From: Angela Makin
Sent: Wednesday, August 30, 2017 1:30 PM
To: Lisa Schreckengost
Subject: FW: SWMU 20 Feature 4 - NMED comment 5 Parcel 6 RFI report
Attachments: Geophysical Anomaly Map - edited.pdf

Subject: SWMU 20 Feature 4 - NMED comment 5 Parcel 6 RFI report

SWMU 20 Feature 4

Fort Wingate Depot Activity
PARCEL 7 SWMU 20 FEATURE 4
AERIAL GEOPHYSICS ANOMALY INVESTIGATION
PROPOSED WORK LOCATIONS AND
TRADITIONAL CULTURAL PROPERTY LOCATIONS
 2817

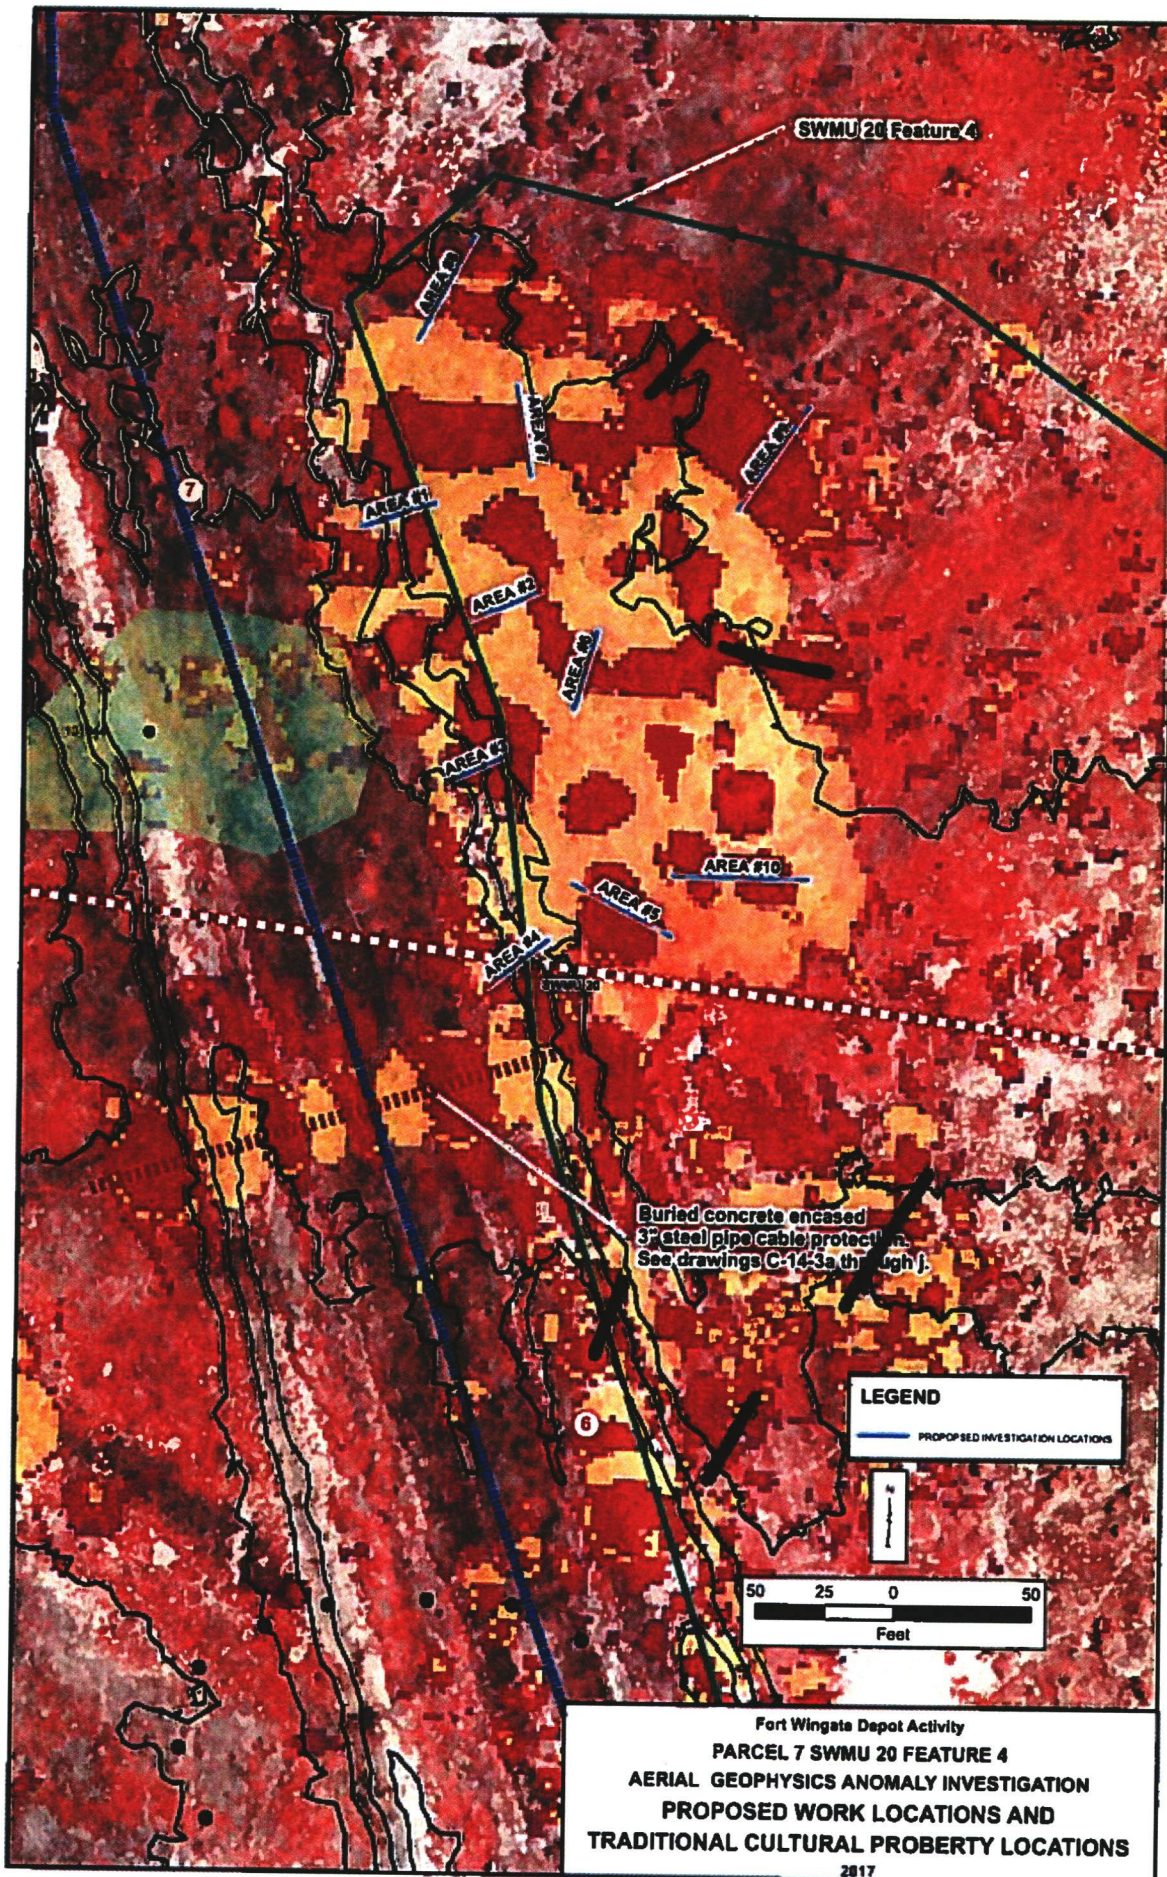
Mike, DJ, Note the black lines Ben added.

Anyway, please see the attached map where I've placed 5 additional locations where NMED would like to see test pits.

Buried concrete encased
3" steel pipe cable protection.
See drawings C-14-3a through j.
